**RE; Residential Development on land to the South of Doncaster Road, Darfield, Barnsley.
In joint application with Keepmoat Homes**

Further to consultation responses provided, we write to provide updated details to directly alleviate concerns that have been identified or seek further clarification.

Approved December 2025 – 2024/0867

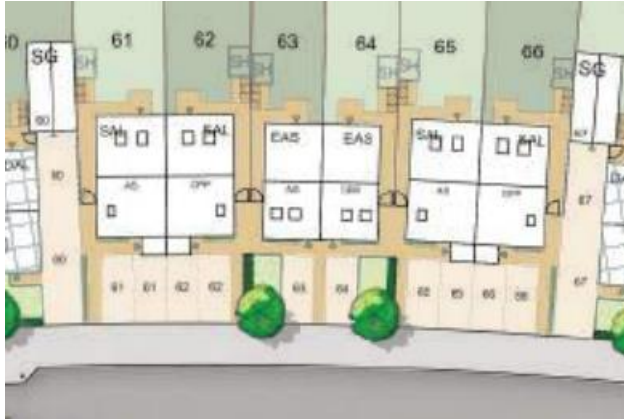
Former Woolley Colliery Site, Woolley Colliery Road, Darton, Barnsley, S75 5JA This identifies parking for integrals and front drive parking with small slithers of landscape between, a couple of which are large enough for tree planting.
